**SR-2 – STAFF ADVISORY REPORT (04-03-2026)**

**ADDRESS:** 4221 CORTLAND

**APPLICATION NUMBER:** HDC2026-00097

**SCOPE:** REBUILD REAR AND SIDE WALLS OF REAR WING; INSTALL FRONT PORCH RAILING

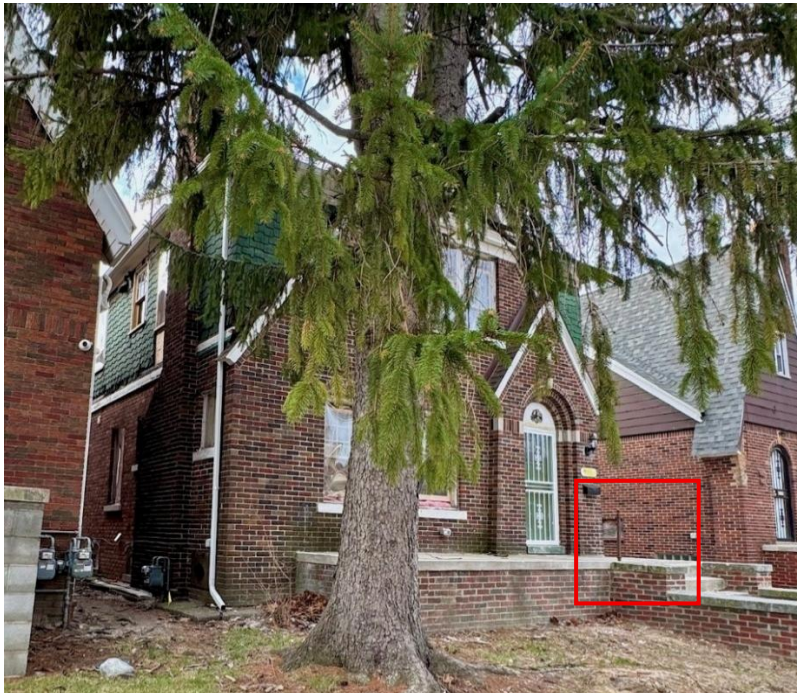
2. The installation of a 36" high railing at the front porch does not match the low height of the historic railing that was removed without HDC approval. The taller metal railing would end above the height of the windowsill at the first floor, and would not provide an appearance that is appropriate to the early 20<sup>th</sup> century historic and architectural character of the dwelling, thus altering the features and spaces that characterize the property.

5. Wood clapboard siding is commercially available and can be purchased and installed with minimal, if any, additional cost. Wood lap siding at this first floor location would retain the characteristics of an early 20<sup>th</sup> century structure and match the materiality and dimensional features of the intact historic wood shake siding at the second floor and wood lap siding at the attic/3<sup>rd</sup> floor dormer wall.

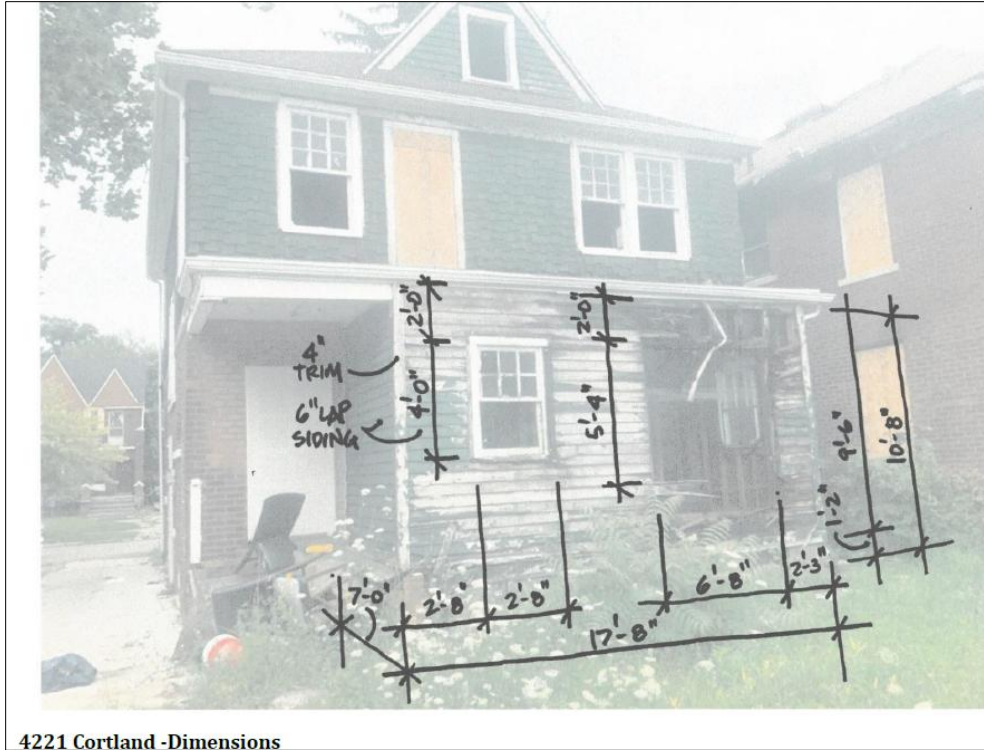
*Applicant photo. With exception of the deteriorated section of the wall, the historic age wood siding on the remaining walls appeared to be intact and in repairable condition.*

- The manufactured composite product does not match the depth, profile, and shadow lines of the previously installed historic wood siding. Installing the substitute product on walls of a historic feature/location, as opposed to being used on new construction (such as an addition or free-standing structure), would create a loss of authenticity and the physical features and characteristics closely associated with the property’s historic significance would be altered.

4221 Cortland - Proposed

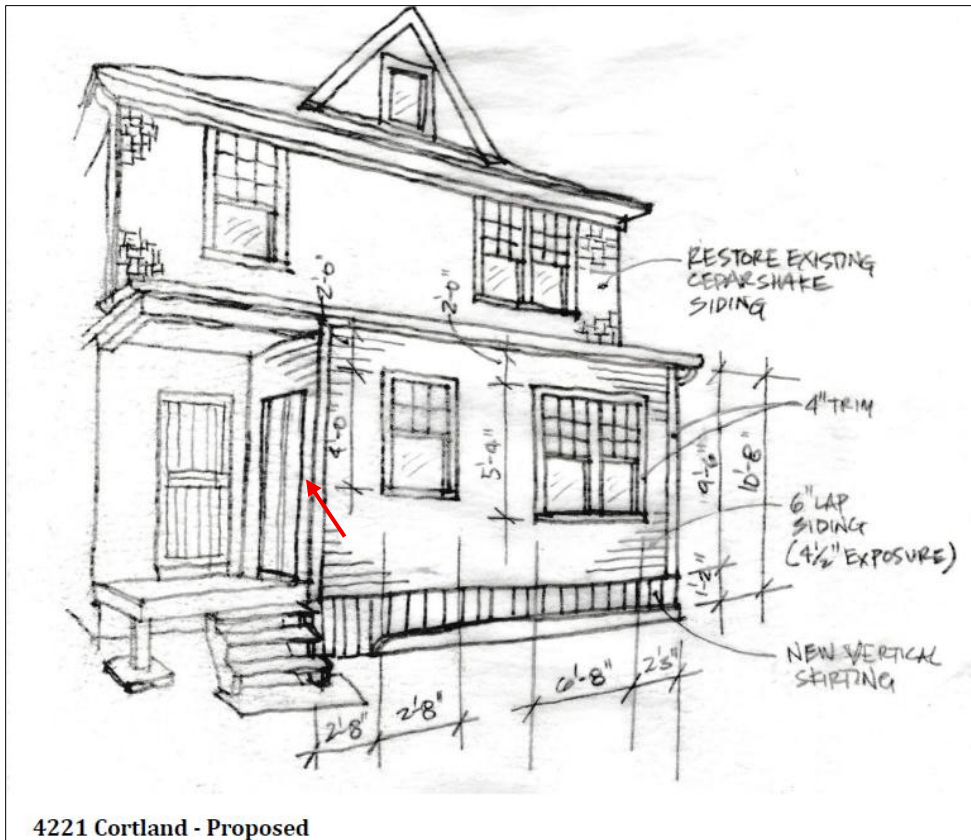
Applicant's proposed design. The opening on the side wall denotes a double door or French door, approved by staff in 2022 (COA 22-7760). Also approved within this COA was the repair and reinstallation of the existing wood windows.
